## TOWN OF STONINGTON

### PROPOSED ZONING TEXT AMENDMENTS TO IMPLEMENT ARCHITECTURAL DESIGN REVIEW

#### **~~7.13.3 Standards for Design Review of Structures.~~**

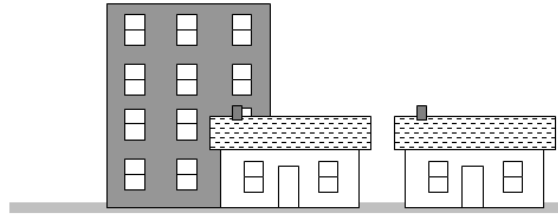
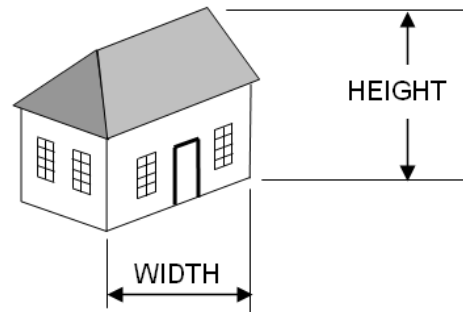
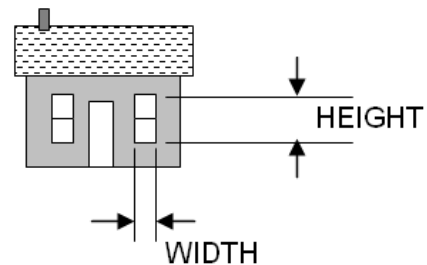
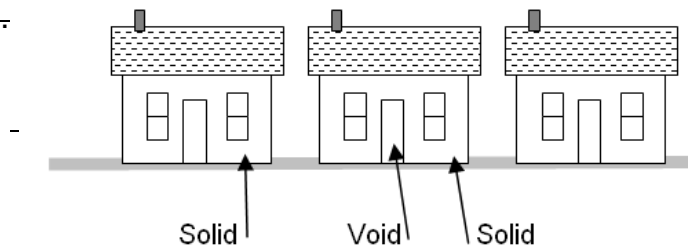
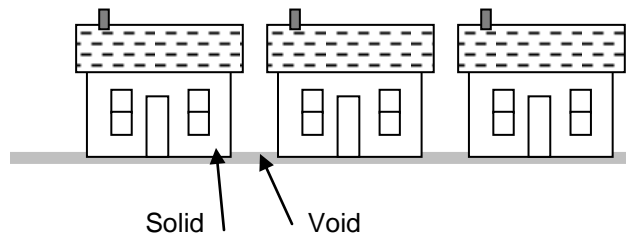
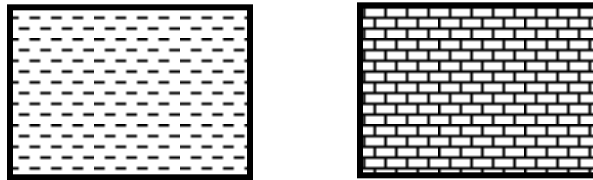
- The first existing element – 7.13.1 (General Review Requirements) has been relocated to Section 2.16 – immediately following 2.15 (Architectural Design Review).*
- The third existing element – 7.13.3 (Standards for Design Review of Structures) has been deleted in its entirety, supplanted by the Design Review process found in Section 2.15.*

~~All buildings and sites subject to a review by the Commission or its staff shall submit scaled elevation drawings of the proposed structures for a design review. The scale of such drawings shall not be smaller than one twentieth (1/20) inch equals one (1) foot. The drawings shall locate and identify exterior materials, fixtures, roof pitch, and building height. The Planning and Zoning Commission shall review the plans for a determination of appropriateness of the design. All determinations will be based on a review of the physical environment within 500 feet of the site, or, if none, by all buildings in a similar zone.~~

- ~~7.13.3.1 Design Review and Determination of Appropriateness. A determination of appropriateness will be made by the Commission (or a subcommittee of the Commission appointed by the Chair for this purpose) using the following criteria:~~
